J A MCDONALD, INC.
VT/AOT BRIDGE – STEEL CULVERT REPLACEMENT
BRIDGE #7, VT ROUTE 58, IRASBURG, VT

B | SHOP DRAWING – B1 | REV 0

Drawing No. C22283–LO2–B1

Quantity: 1 | Project No: STPCULV30 | SHEET 1 OF 9

REINFORCING DETAIL

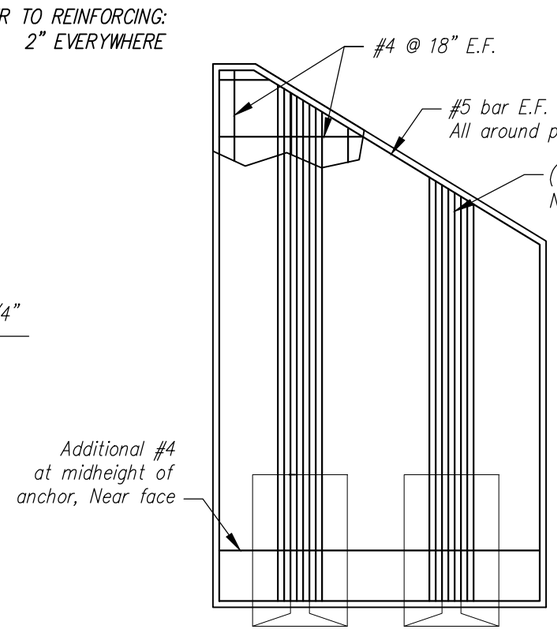
Need to specify a spacing or total width for the additional #8 bars
